PROJECT SCOPING PLAN FOR PERFORMING A CERCLA
REMEDIAL INVESTIGATION/FEASIBILITY STUDY (RI/FS) AT
THE FILL AREA WEST OF BUILDING 135 (SEAD-59), AND THE
ALLEGED PAINT DISPOSAL AREA (SEAD-71), SENECA ARMY
DEPOT ACTIVITY

APRIL 1997

**PROJECT SCOPING PLAN
REMEDIAL INVESTIGATION/FEASIBILITY STUDY
AT SEAD-59 and SEAD-71
SENECA ARMY DEPOT ACTIVITY
ROMULUS, NEW YORK**

FIGURE 4-1
 LOCATION OF EXISTING AND PROPOSED SAMPLING POINTS

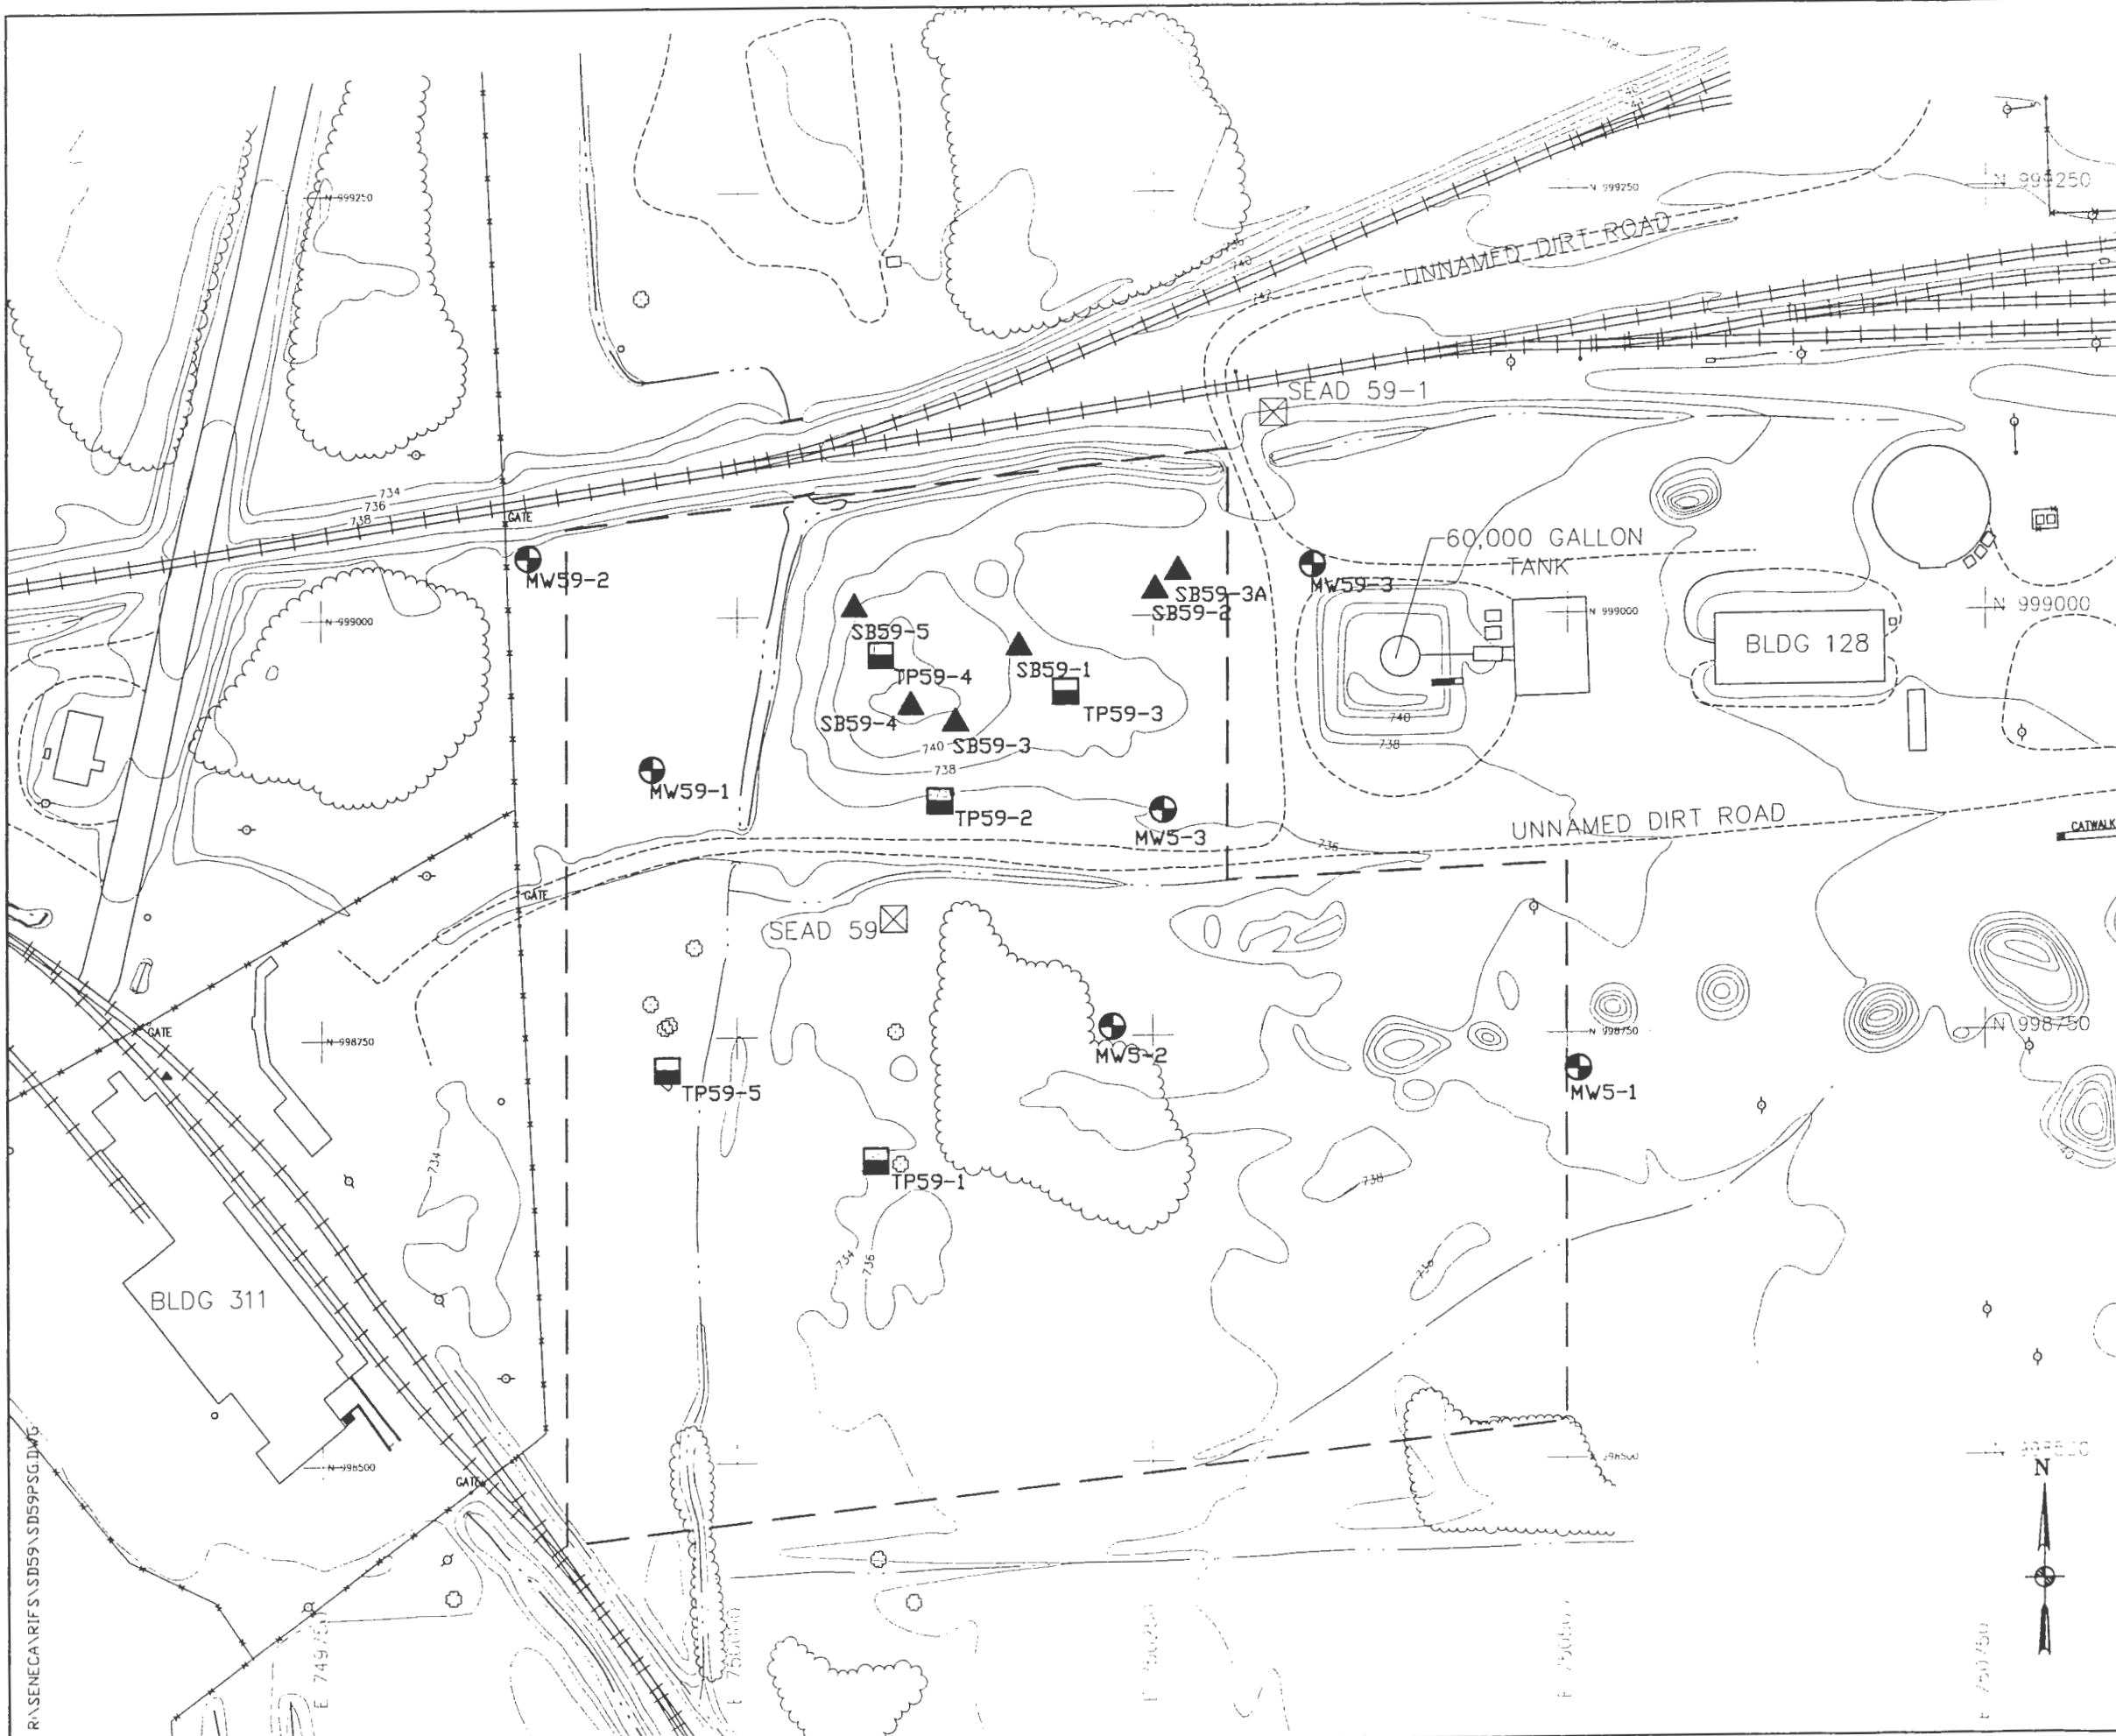
- Comment #19** Figures 4-3: As with Figure 4-5, groundwater contours should be shown on this Figure. Also the locations of monitoring wells MW5-1, MW5-2, and MW5-3 should be shown on this Figure as they are on Figures 3-11 and 3-12. The rationale for the proposed location of monitoring well MW59-6 should be provided. The proposed location for this well is approximately 60 feet from Test Pit TP59-6 in which 2,100,00 ug/kg of BTEX was present. Proposed well MW59-6 should be moved next to this test pit in order to better characterize groundwater quality in this area.

Response #15 Acknowledged. The locations of the additional surface water and sediment samples SW/SD59-5 and SW/SD59-13 are shown on Figure 4-1 (formerly Figure 4-3). The text has been revised so that it is clear which samples are the two nearby off-site samples.

- Response #16** Agreed. To address possible vertical impacts at the site three (3) shallow bedrock monitoring wells have been proposed. Two of the bedrock wells are proposed in downgradient locations and one is proposed as a background location. The text in Section 4.2.5.1 and Figure 4-1 were revised to reflect this change in the field program.

- Response #19** Agreed. The wells MW5-1, MW5-2, and MW5-3 were added to this figure. Also, well MW59-6 was moved so that it is closer to test pit TP59-6 as recommended in the comment. But, we do not believe that it is necessary to show the groundwater contours on this map because this would make the map look cluttered and more difficult to read; however, the groundwater contours are shown on Figure 3-7. The location of this well on Figure 4-1 was revised.

Response #1 Agreed. The Scoping Plan currently calls for a till/weathered shale well near TP59-1, and based on EPA comments this wells has been moved even closer to the test pit location; also, a bedrock well is proposed for this location as well. Because the comment suggests that multiple wells will be necessary to define the extent of the possible VOC impacts in groundwater, another well has been proposed to be installed even farther downgradient of TP59-1, near the SEAD-59 boundary. The text in Section 4.2.5 was revised as well as Figure 4-1.
